SUNDRY NOTICES AND REPORTS ON WELLS

**DEVON ENERGY PRODUCTION COMPANY LP** Well Name: SPRINGS 2 FEDERAL #1 Field: CATCLAW DRAW Location: 2375' FNL & 2300' FEL; SEC 2-T21S-R25E County: EDDY State: NM Elevation: 3225 GL Spud Date: 6/21/00 Compl Date: 9/13/00 API#: 30-015-31236 Prepared by: Ronnie Slack Date: 1/6/09 Rev: Proposed for SWD Formation Top-MD Queen 858 1787 17-1/2" hole Cherry Canyon 13-3/8", 48#, H40, ST&C, @ 453' Brushy Canyon 1996 Bone Spring Limestone 3310 Cmt'd w/500 Sx. Cement to surface. 8050 Cisco Atoka 9770 Morrow 10090 TOC @ 1190' (CBL-9/6/00) Proposed 12-1/4" hole 2-7/8", IPC tubing 8-5/8", 32#, K55, ST&C, @ 2,170' Cmt'd w/910 Sx. Cement to surface. Proposed 5-1/2" IPC Injection Packer @ +/- 2205" Proposed Perfs for SWD DELAWARE BRUSHY CANYON 2236' - 2242' (open--tested 8/6/08-wet) 2243' - 2255' (proposed new perfs) 2269' - 2275' (proposed new perfs) Proposed Set CIBP @ 2510'. Cap w/35' cement. PBD @ 2475' DV Tool @ 7787' 35' cement. PBD @ 8055' CISCO CANYON (2/15/08) CIBP @ 8,090' (8/6/08) 8,108' - 8,126' (wet) 2/20/08: 2 stg acid job w/15% 35' cement. PBD @ 8195' CISCO CANYON (2/12/08) CIBP @ 8,230' (2/15/08) 8,266' - 8,282' 3 spf, 120° (wet) 2/13/08-acidized

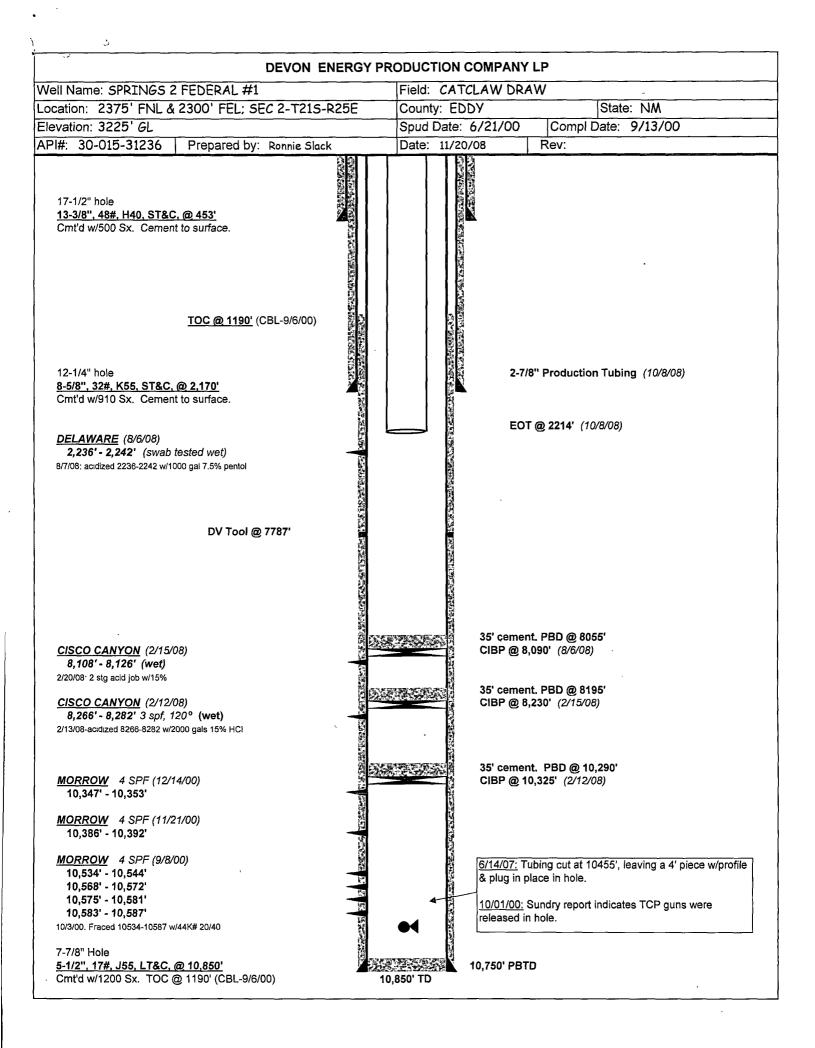
- 2. Notify BLM at 575-361-2822 prior to plug back for conversion.
- 3. Additional cement is required on top of the CIBP at 8090'. With the existing cement, this plug is approximately 8055'. Plug needs to be a minimum of 50' above the top of the Cisco Canyon formation at 8050'.

- 4. Plug required across the DV tool at 7787'. Plug to be 180' in length and a minimum of 25 sacks. Plug to be set a minimum of 50' below DV tool depth and is to be tagged.

- 5. Plug required at the top of the Wolfcamp formation (depth 7676' from the Levers Federal 1). It is recommended that additional cement be used in step 4 to also cover the Wolfcamp. The combined plug is to be tagged at 7600' or shallower.

- 6. Plug required at the top of the Bone Spring formation. Plug to be 135' in length and a minimum of 25 sacks. Plug to be set from 3360-3225'.
- 7. Remainder of procedure is okay.
